Subject: Delta Wetlands Project Supplemental Draft Environmental Impact Statement, San Joaquin and Contra Costa Counties, California [CEQ# 20150154]

U.S. EPA DETAILED COMMENTS ON THE SUPPLEMENTAL DRAFT ENVIRONMENTAL IMPACT STATEMENT FOR DELTA WETLANDS PROJECT, SAN JOAQUIN AND CONTRA COSTA COUNTIES, CA
JULY 10, 2015

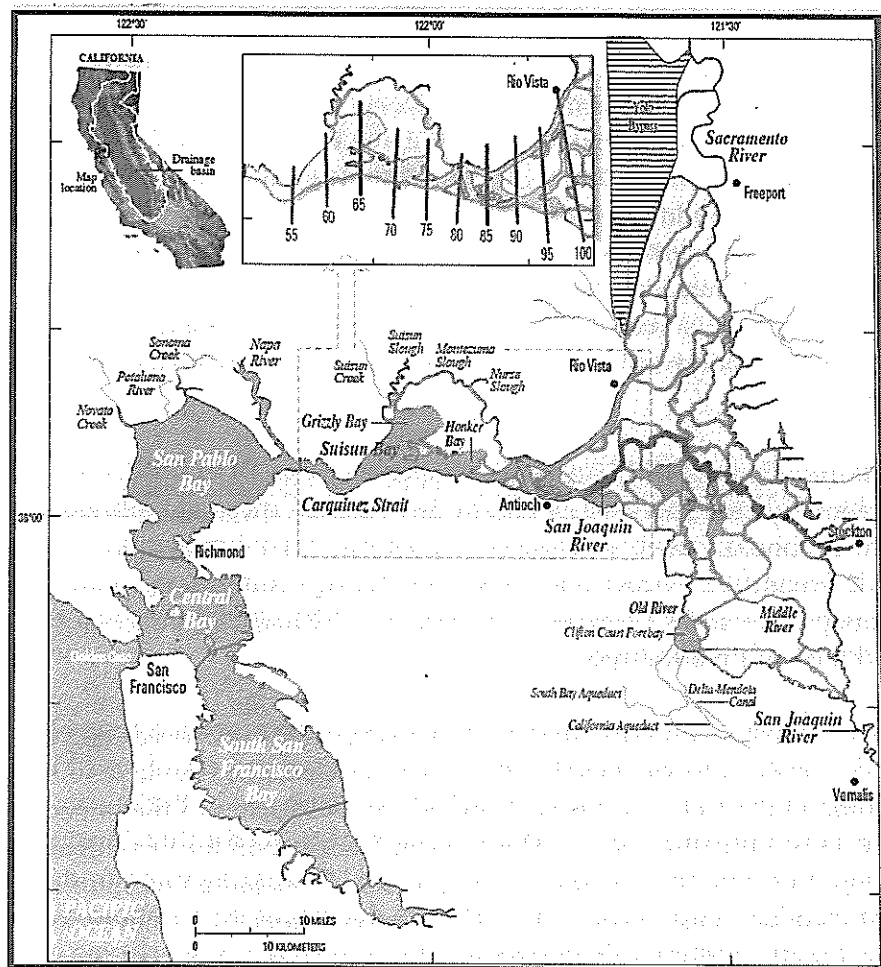
The SDEIS explains that, in addition to other variables, the project diversions would occur at times when the 2 parts per thousand salinity isohaline ('X2') is positioned downstream of Chipps Island measured at 75 km from the Golden Gate (page 2-37; and Figure 1 below). This metric was selected to ensure that water diverted onto the islands is of low salinity and to ensure that diversions would be unlikely to have negative impacts on fish species (page 3.11-5). However, EPA believes that an X2 of 75 may not be the best location for creating a low salinity zone that supports fish populations, nor a reliable value upon which to trigger project diversions. Wet years have lower seasonal X2 values (fewer kilometers) than dry years as higher flows push the 2ppt isohaline westward toward the Golden Gate. Spring typically has lower X2 values and summer and fall have higher X2 values. Estuarine habitat that supports native resident and migratory fishes has X2 values that vary annually and seasonally consistent with the California climate.

The project applicant proposes to divert water to the reservoir islands when X2 is 75 km in a *below normal* or *dry* year. The SDEIS also indicates that the project diversions themselves may impact the

location of X2 (page 3.11-5). EPA is concerned that this diversion trigger may degrade water quality in the Delta by allowing salinity intrusion, and adversely affect aquatic life. We believe that water resource managers should allow the location of X2 to vary seasonally and annually with the amount of precipitation received by California, and strive to place the low salinity zone between Carquinez Strait and Chipps Island (e.g., between 55 and 75 km).

Recommendation: The SFEIS should evaluate the forecasted monthly average X2 under the proposed project alternatives and compare the results to baseline conditions, providing a clear analysis of how X2 would be modified as a result of project operations.
